Project	IEEE 802.16 Broadband Wireless Access Working Group < <a href="http://ieee802.org/16">http://ieee802.org/16</a> >		
Title	Some Modification on the Procedure of New sub-frame Creation		
Date Submitted	2006-11-10		
Source(s)	Shulan Feng Hisilicon Tech. Co., LTD Bld.17, No.8, Dongbeiwang West Road, Hai-Dian District, Beijing, P. R. China	Voice: Fax: e-mail to:	+86-10-82829151 <a href="mailto:fengsl@hisilicon.com">fengsl@hisilicon.com</a>
Re:	IEEE 802.16 Letter Ballot #24 (on P802.16h/D1) is now open		
Abstract	This contribution gives some analysis about the new sub-frame creation and suggests modifying the procedure of new sub-frame creation.		
Purpose	Modify the procedure of new sub-frame creation.		
Notice	This document has been prepared to assist IEEE 802.16. It is offered as a basis for discussion and is not binding on the contributing individual(s) or organization(s). The material in this document is subject to change in form and content after further study. The contributor(s) reserve(s) the right to add, amend or withdraw material contained herein.

## Some Modification on the Procedure of New Sub-frame Creation

Figure 1

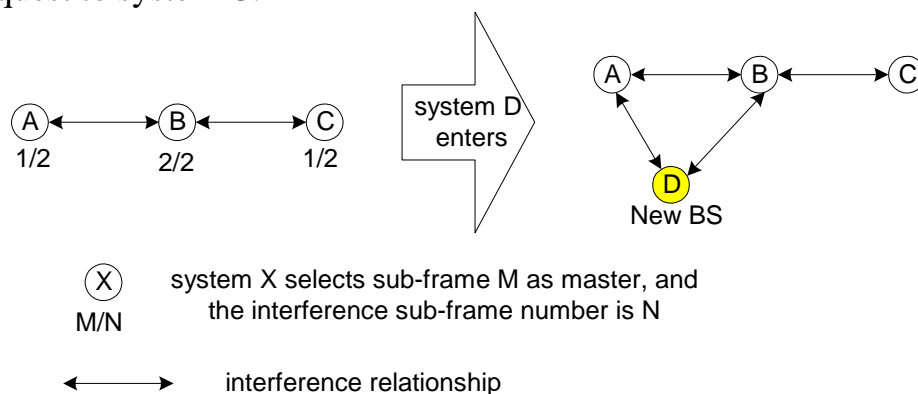
In the current 16h draft, new BS will send the request of new sub-frame creation to all member BSs of the community. Because the new BS only knows its neighbor BS, to implement this function may need some additional message. For the interference relationship shown in figure 1, when system D enters interference community, it will know system A and system B are its interference neighbors and not know the existence of system C in the same community unless the system B informs it. If the system D is requested to send requests to all member BSs in the community, system B must inform system D of the existence of system C or system B must forward the request to system C.

Figure 2

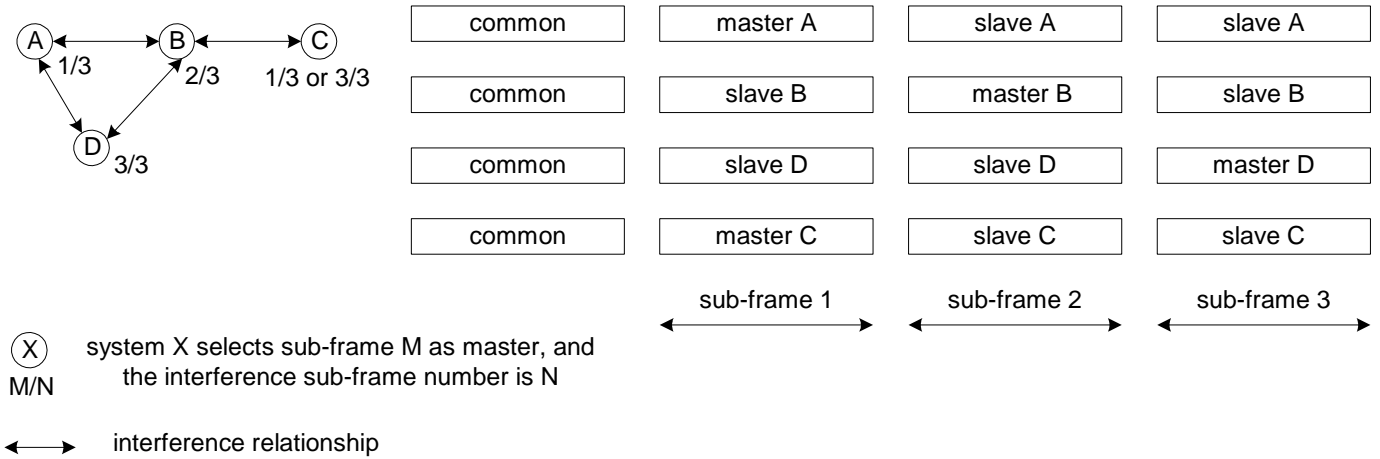
Furthermore, adding new sub-frame to all member BSs in the community may decrease the resource efficiency as shown in figure 2. In this case, and as the definition of sub-frame (15.4.2.1.2), system C may select sub-frame 1 or sub-frame 3 as its master. This is not an efficient way.

Figure 3

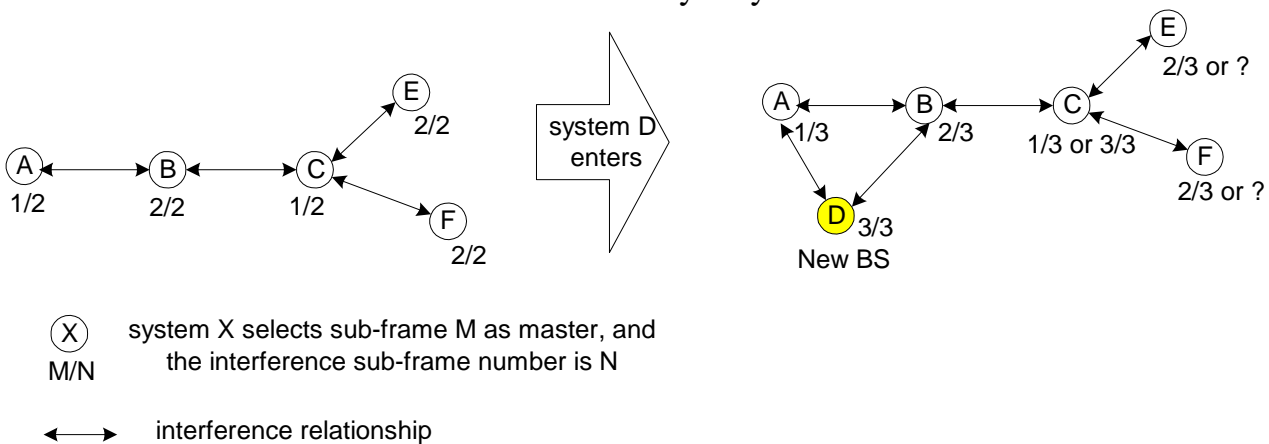
If system C selects both sub-frame 1 and sub-frame 3 as its mater, then efficiency can improve but we must do some modifications to the current protocol, such as the information database. Furthermore if the interference community is more complex, then every system in the community must change its frame structure. The request message must forward to every system in the community and the coordination between systems may be intolerable. The signaling overhead is increase and the resource efficiency may decrease.

Figure 4

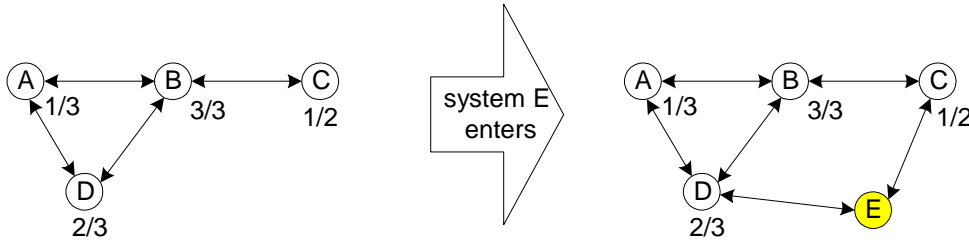
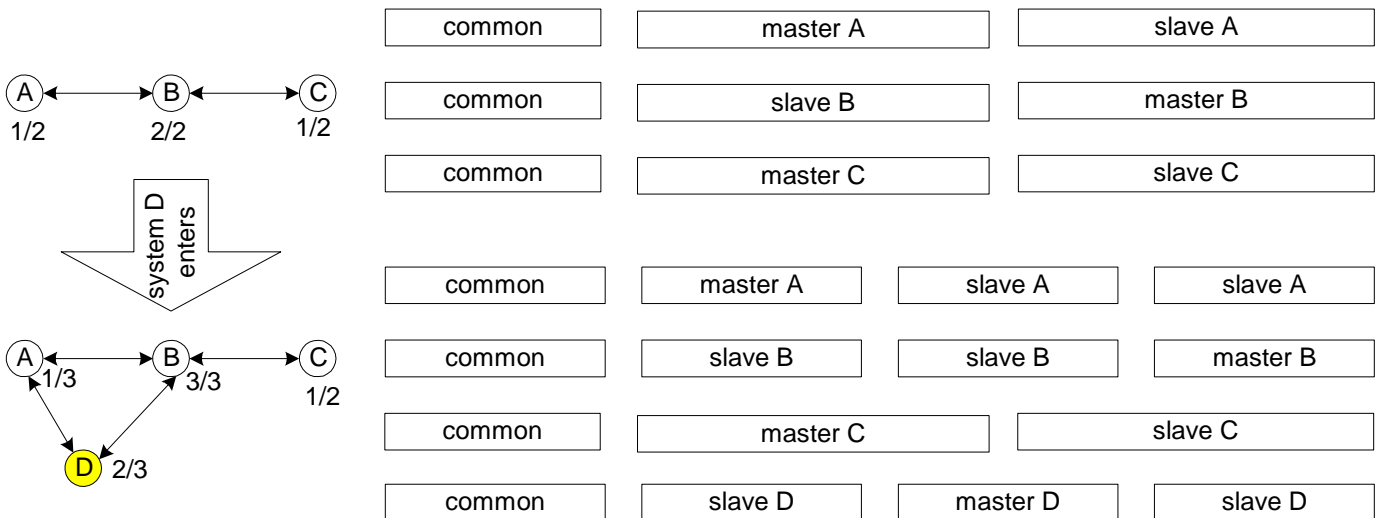
For some cases, such as the sub-frame number of interference of neighbor is not same, it need

not to request all neighbor BSs increase the sub-frame number of their own. For example, when system E enters community, it need not to request system D increases its sub-frame number as shown in below figure.

So if none of the existing sub-frames can be used, the new BS may request some of its neighbor BSs to increase their sub-frame number only. If all neighbor BSs have same sub-frame number, then the new BS may request all its neighbors to add a new sub-frame. And the BSs which have not direct interference with new BS main remain their frame structure unchanged. If the sub-frame number is not same, then the new BS may request the neighbors which have lower sub-frame number to add new sub-frame so that all neighbors use same sub-frame number. And the BSs which have maximum sub-frame number or the BSs which have not direct interference with new BS may remain their frame structure unchanged. Figure 5, 6 and 7 give some example.
